MEMORANDUM

TO: Board of Zoning Adjustment
FROM: Arthur, Jackson, Case Manager
 Joel Lawson, Associate Director, Development Review
DATE: May 6, 2014
SUBJECT: **BZA Case 18753** – Request for a special exception under § 214.1 to continue operation of the existing accessory parking lot on properties located at 3820-3826 McKinley Street, NW

Figure 1

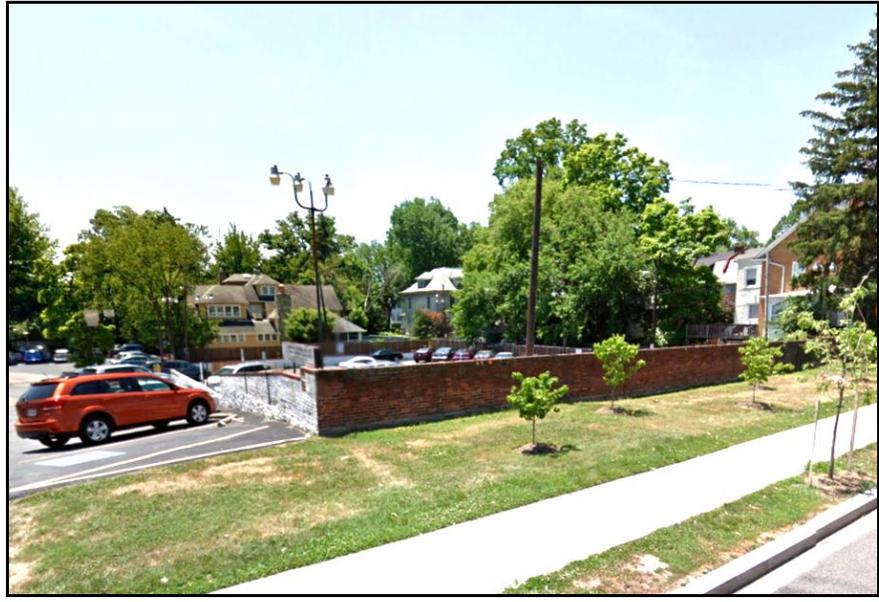
The parking area is free to refuse and debris. In response to concerns expressed during the review of the 2009 application, and as required in the current BZA order, trees have been planted along the McKinley Street within the building restriction line along that frontage (refer to Figure 1).

Accordingly, OP supports modifying condition #4 to instead require proper care and maintenance of the existing landscape (additional landscaping in this area is also encouraged).

4. The parking lot landscaping shall ~~be planted within six months of the date of final BZA action and prior to the issuance of the Certificate of Occupancy for the parking lot use~~ **be properly maintained or replaced as needed.**
